PCN No.: EC-20250906-PCN-04	PCN Doc No.: PCN-202509-080	Date Issued:	2025/9/6
Part Number or Series: 2RS2R-XX-G	PCN Effective Date:	Not affected	
Customer: (If applicable)	P/O No.: (If applicable)	Not affected	
Type of Change:	■ Mfg location Change / Qualification / Country of Origin (COO)	Last Time Buy Date:	Not affected
	■ Design Change / Data Sheet Spec Change		
Traceability Marking/Date code: No change	Last Time Ship Date:	Not affected	
Replacement Part Number: 2RS2R-B-XX-G-HT	Sample Availability Date:		
Change Description: To enhance our production flexibility and ensure a stable supply chain, we will be expanding manufacturing to multiple locations for the above-mentioned part(s). This strategic adjustment is designed to improve efficiency and reliability in meeting your demand.			
Reason for Change: This change is implemented to optimize our global manufacturing capabilities, allowing us to dynamically allocate production resources based on current order conditions and market needs, ensuring timely delivery and quality consistency.

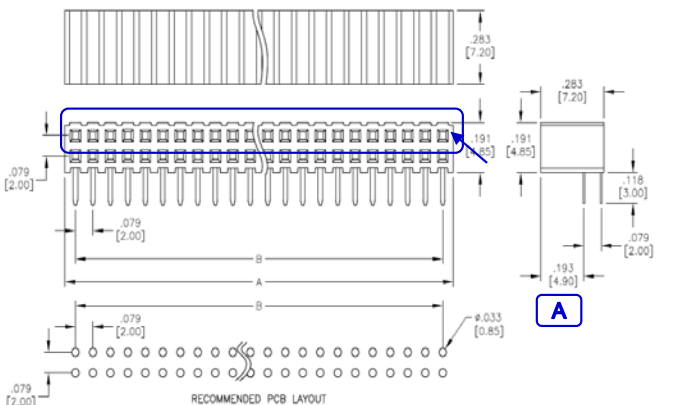
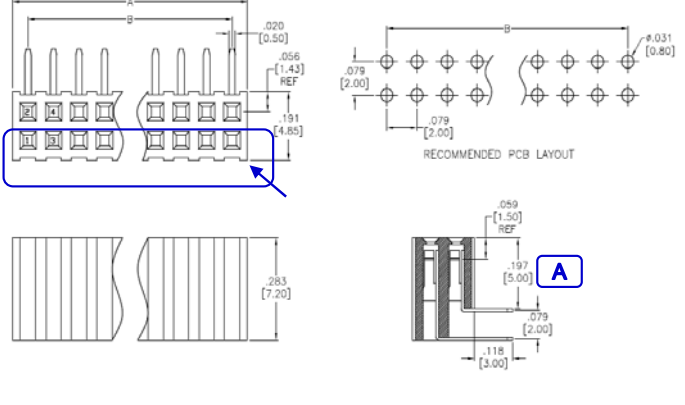
Impact of Change: P/N change, There are slight differences in appearance and size;

Before Change	After Change
 RECOMMENDED PCB LAYOUT IS: -temp thermoplastic, rated UL 94V-0 Positions: 04 thru 80 A = .079 [2.00] x No. of Positions per Row + .016 [0.40] B = .079 [2.00] x No. of Spaces	 RECOMMENDED PCB LAYOUT c, rated UL 94V-0 Positions: 04 thru 80 A = .079 [2.00] x No. of Positions per Row + .016 [0.40] B = .079 [2.00] x No. of Spaces
Before the change: - Appearance ~ As shown in the above picture; - Size: A) 4.90	Before the change: - Appearance ~ As shown in the above picture; - Size: A) 5.00
